1 Products affected

Product hierarchy no.				Part no.	SBU	Product Type
SBU	PG	PUG	Type			
01	002	004	0000000616	3-141-376	Circuit Protection	FXP

Product Change Notification					PCN FXP Change of product design		
owner	creation date	release date	released by	change order	rev	page	D10-078-396
kraftal	07.09.2023	21.09.2023	schulejo		A	1 of 1

Current product appearance	New product appearance

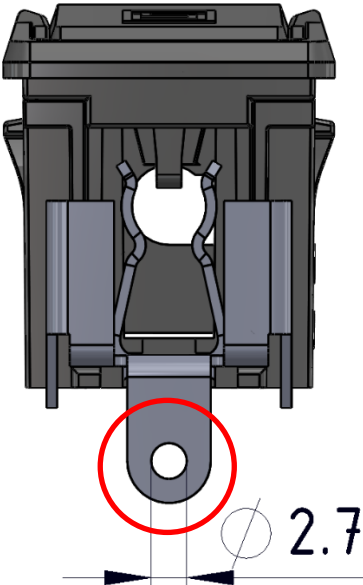
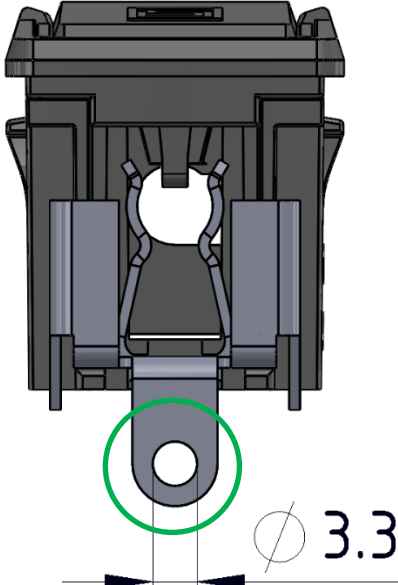
- Changed size of terminal holes from 2.7 to 3.3 mm

- 6mm² / AWG10 stranded wire can be inserted for easier soldering

| <input checked="" type="checkbox"/> Form | No action required, consider new appearance at incoming inspection |
